UN Global Technical Regulation No. 7 (Head Restraints)**Proposal for Amendment 1 (Phase 2) to UN Global Technical Regulation No. 7 (Head Restraints)****Submitted by the expert from the European Association of Automotive Suppliers ***

The text below was prepared by the expert from the European Association of Automotive Suppliers (CLEPA) to amend the static options of the proposal of amendment 1 of UN Global Technical Regulation No. 7 submitted by the Informal Working Group on the Phase 2 of UN GTR No. 7 (ECE/TRANS/WP.29/GRSP/2018/27). It is based on informal document GRSP-64-25, distributed at the sixty-fourth session of the Working Party on Passive Safety (GRSP), which is also relevant for the Phase 2 of the GTR. The modifications to ECE/TRANS/WP.29/GRSP/2018/27, are marked in bold or strikethrough characters.

"Figure 3-3

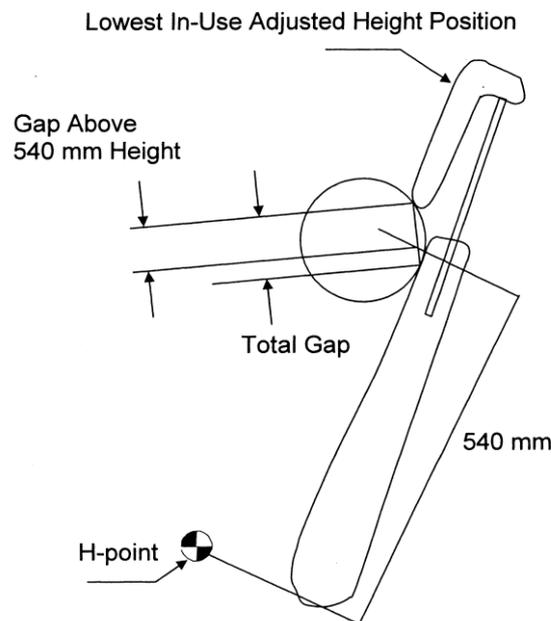
- "2.5. Determine the gap dimension by measuring the straight line distance between the inner edges of the two furthest contact points, as shown in Figures 3-1, ~~and 3-2 and 3-3.~~"

Annex 3, insert a new Figure 3-3, to read:

Portion of gap above 540mm.

"Figure 10-1

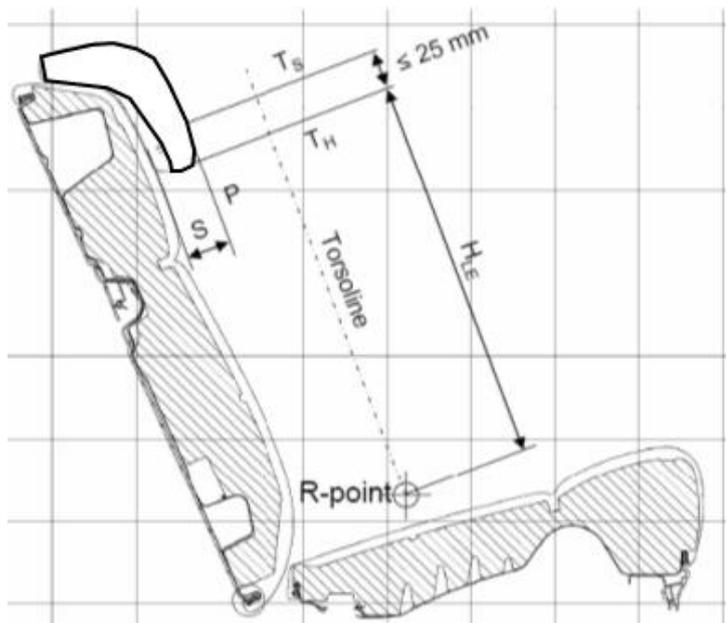
Annex 10, figure 10-1., amend to read:
